Our Ref: PL/26/0775  
Your Ref:

**RE: PROPOSED WORKS TO 7 NO. PLANE TREES AT HARTWELL FORD, 27 ROSE KILN LANE, READING - T1-T7 OF TREE PRESERVATION ORDER NUMBER 2/10.**

**Figure 1: T1 - lowest branch growing over the car park to have secondary branches crown lifted to 2.5m above ground level**

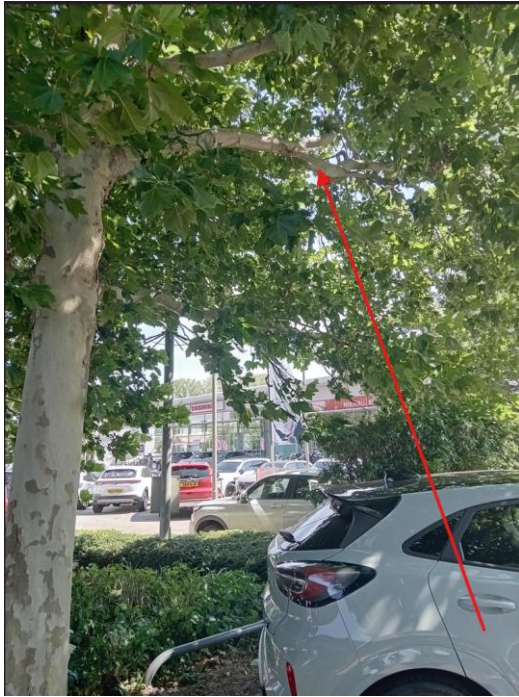
- T1: crown lift the secondary branches from the lowest branch growing over the car park to approximately 2.5m above ground level (Figure 1); remove epicormic growth on the south aspect to just above the height of the camera (see Figure 2 for examples); prune to create 0.5m of horizontal clearance from the lamp column and 0.5m of vertical clearance of the lamp head (see Figure 2); crown lift secondary

Figure 5: T5 - lowest secondary branch growing over the car park to be removed back to source

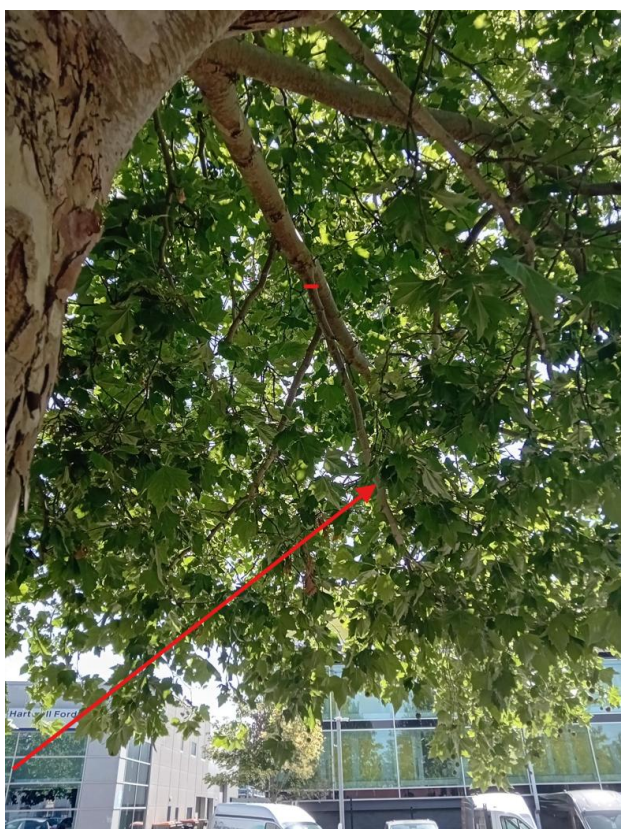
- T5: remove the lowest secondary branch growing over the car park back to source (see Figure 5); crown lift secondary branches only to 5.5m above ground level over the public road; crown lift secondary branches only to 2.75m above ground level over the public footpath; crown lift over the car park to 3.5m above ground level by removing secondary growth only and leaving suitable growth points

Figure 6: T7 - lowest, previously reduced branch growing over footpath to be removed back to source

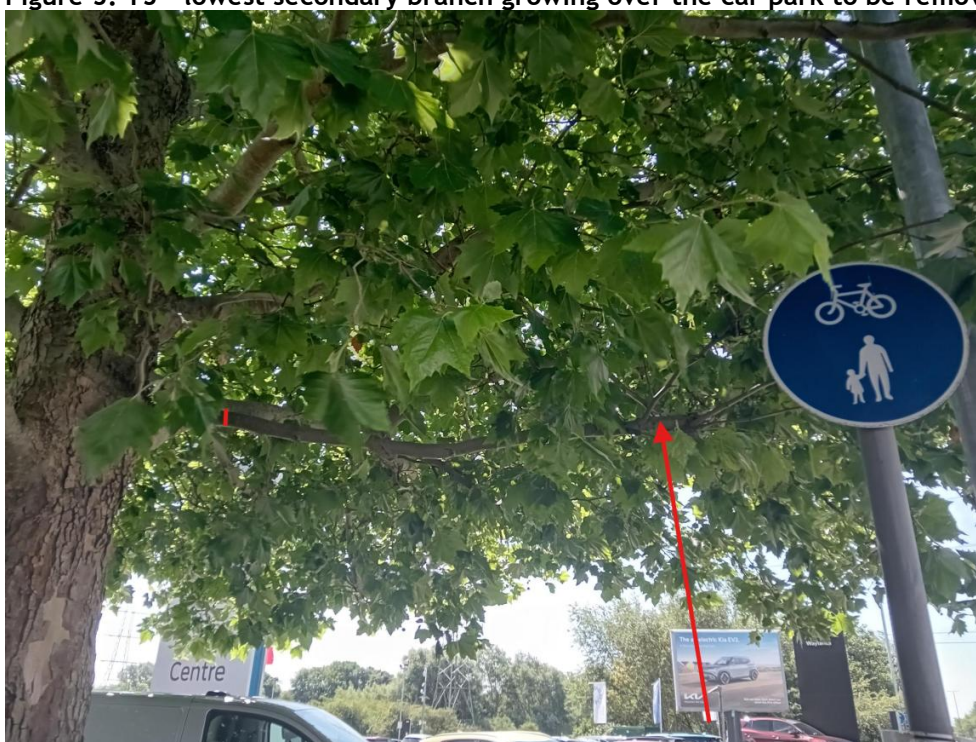
- T7: remove the lowest, previously reduced branch growing over the public footpath back to source (see Figure 6 & 7); reduce 2no. secondary branches (see Figure 8 - upper conflicting with lamppost; lower notably damaged) growing over the public footpath/road & adjacent to the lamppost back to the point indicated in Figure 8, retaining the non-annotated branch as a growth point; crown lift secondary branches only to 5.5m above ground level over the public road; crown lift to 2.75m above ground level over the public footpath; crown lift over the car park to 3.5m above ground level by removing secondary growth only and leaving suitable growth points
